533-2026 ADDENDUM 2

LOUISE BRIDGE SUBSTRUCTURE REHABILITATION AND RIVERBANK STABILIZATION WORKS

ISSUED: August 6, 2026
BY: Brad Neirinck, P. Eng.
TELEPHONE NO. 204-794-4311

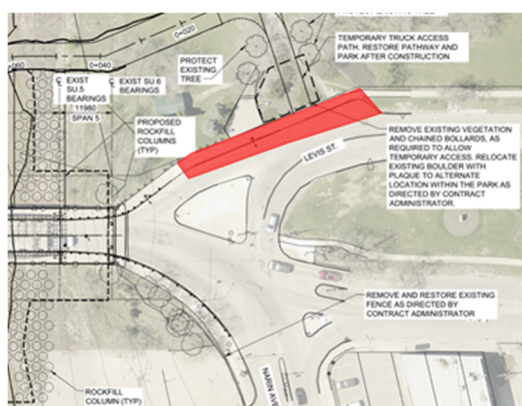
Q31: Is it acceptable in principle for the Contractor to drop a lane of southbound Levis St immediately north of the bridge for the duration of the north bridge works, including the west sidewalk? This would facilitate trucks turning into/out of Ernie O' Dowda Park and for equipment mobilization/demobilization. See below diagram for reference?

A31: In principle the curb lane and sidewalk closure is acceptable, however a closure request would be required through the City Traffic Management Branch. Generally, the sidewalk on the west side of Levis between Nairn and Midwinter can be closed. The SB Levis curb lane can be closed as provided thru traffic on southbound Levis is able to access the bridge to southbound Higgins as well as maintaining eastbound traffic through the Levis/Nairn/Stadacona intersection. Any Transit stops affected by the lane closure will likely be either temporarily cancelled or relocated.
